INDESIT company

Model type:
WA8XSIT

Commercial code:
F026919

FIG. 1

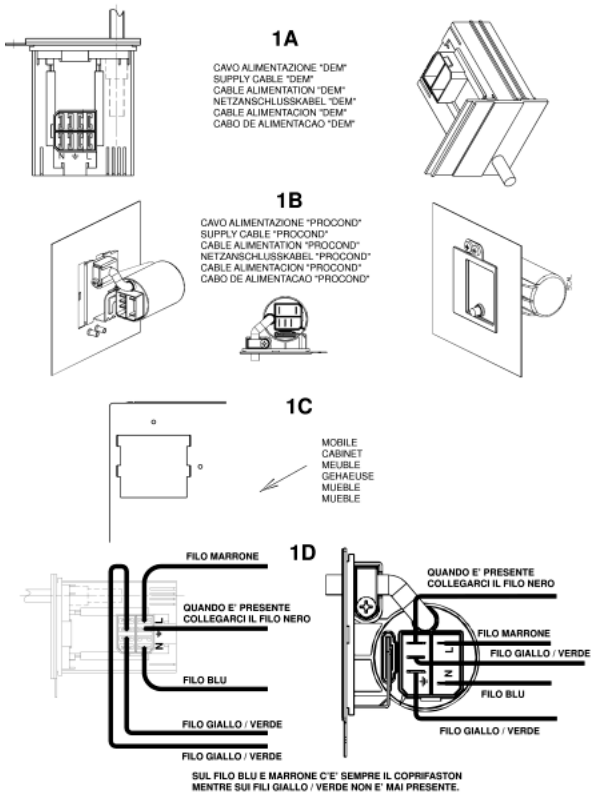
All appliances produced in the Comunanza (from serial no. 21008.0001), Teverola (from serial no. 21111.0001) and Brembate (from serial no. 21119.0001) factories have been equipped with power supply cables with integrally moulded filter (see fig.1 - 1A and 1B) and new units having a specific opening at the back for fixing the new cables (see fig. 1 - 1C).
The new units, together with the new cables, can be used in place of the premodification ones, by connecting the wiring to the cable, as shown in figure 1 - 1D.
The codes of the new units and of those replaced (ESI - table n1040276fig02), which will be managed until stocks run out, are given below.

IMPORTANT: the fixing / continuity screw is a specific self-scraping screw (code 092348) that ensures earth continuity between the filter and the unit. The same screw must be refitted in order to guarantee machine conformity.

The premodification wirings, are also managed for modified products by making the connection to the terminal block of the new cable as shown in fig. 1 - 1D.
The wiring diagrams given in the Documentation remain unchanged.

The new power supply cables are:
Code 091632 - Power supply cable 3x1 schuko 1.5m+capacitance filter;
Code 091633 - Power supply cable 3x1 schuko 1.5m+inductive filter;

Code 091634 - Power supply cable UK 3x1 l= 1950mm + inductive filter;
Code 091635 - Power supply cable UK 3x1 l=1950mm+capacitance filter;
Code 091636 - Power supply cable l=2.55m AUS+inductive filter;
Code 091641 - Power supply cable l=2550mm AG +capacitance filter;
Code 091642 - Power supply cable 1.85mt SHUKO no inductive filter;
Code 091643 - Power supply cable 3x1 (CH) 1.5m+inductive filter;
Code 091645 - Power supply cable 3450mm SOUTH AF.+capacitance filter;
Code 091690 - Power supply cable shuko l2.55m KOREA+inductive filter;
Code 091689 - Power Supply cable l=2550mm AG+inductive filter.

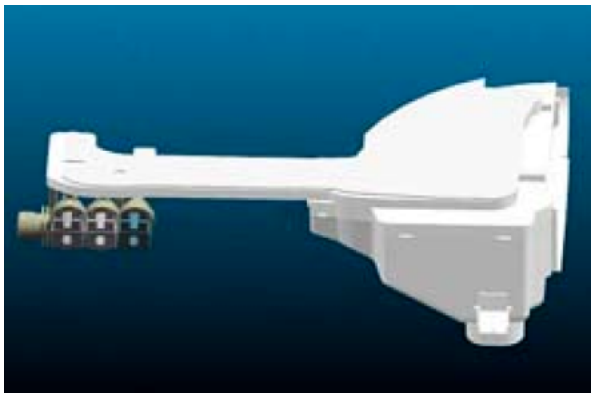
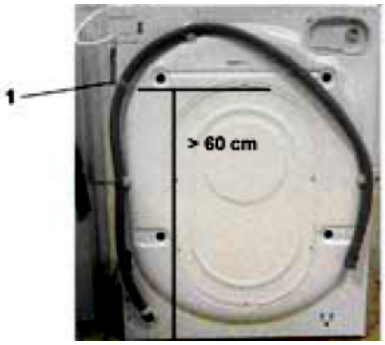
From serial number 21219.0001, the new "OKO" drainage system has been introduced on the washing machines produced in the Comunanza factory.

- EEPROM (the OKO system requires a new setting of load timing parameters). THE NEW EEPROMS REPLACE ALL THE ONES CODED PREVIOUSLY.
- BOWL (hopper tube hole shifted forwards);
- DETERGENT LOADING TUBE (see fig. 1);
- PRESSURE SWITCH (changed levels);
- OKO PUMP BOWL BLOWER + BALL (see fig. 2A, 2B and 2C);
- CONDUCTIVITY SENSOR (if provided, it is shorter than the premodification item);
- DRAIN PUMP (without detergent collecting tube connection);
- HOPPER (shifted in front of detergent loading tube connection). Fig. 3A post-modification. Fig. 3B premodification);
- AIR TRAP (different shape);
- PRESSURE SWITCH TUBE (different length);
- DRAIN TUBE STOP (specific);

In particular, the OKO system consists of a spherical plastic component inserted in the tube that connects the bowl to the drain pump (see fig.2 A).
At the beginning of each wash cycle the washing machine fills water for 10 seconds and activates the drain pump for 2 seconds. In this way, the water level in the bowl is different from that in the drain tube; this difference increases the thrust of the ball upwards, closing the bowl-pump connection tube hermetically (see fig. 2D).
This system has the double advantage of:

1) separating the wash water and the water in the drain hose, thus saving energy during the heating phase;
2) and ensuring optimal use of all the detergent.
With the introduction of this new component, the detergent collecting tube is no longer required and the pump has one hole only to convey water from the tank.
For the correct operation of the OKO system, it is important that the drain hose of the washing machine remains fixed to the back of the unit with a plastic clamp (to this end, the clamp withstands a 25 kg load; see reference 1 in fig. 4); otherwise, the drain hose must absolutely reach the height of the clamp. (minimum 60 cm.)

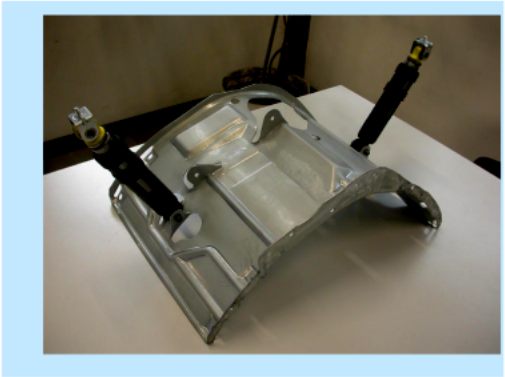
From serial no. 40427.0001, shock absorbers have been fixed to the tank unit cradle with two 11 mm pins code C00110163 (see fig. 01 and 02 enclosed) in place of the 8 mm screws code 093750 and relevant locking nuts code 030443, on all washing machines and dryers produced in the Comunanza factory.
The items affected by this modification are:
1) The cradles have the same Service code, as they can be used in place of the new ones after widening the shock absorber fixing holes to a diameter of 10 mm.

Code 093848 - Tank unit cradle 46 lt
Code 093878 - Tank unit cradle 40 lt.
2) The new shock absorbers, with fixing bushing having no s/steel spacer, are not managed as they are interchangeable with the premodified items (make sure they are CIMA type, as the managed items), fixed with M8 screws code 093750 and related locking nut code 030443 (see figs. 05 and 06).
Code 093884 - Shock absorber 80 N
Code 093885 - Shock absorber 100 N

To remove the shock absorber from the tank, first extract the pin with a few hammer taps (see fig.03) until it is aligned with the tank bracket and then pull it out with a pair of pliers (see fig. 04).
(To refit the shock absorber use a new pin. Insert the pin until the toroidal edge is aligned with the bracket.)
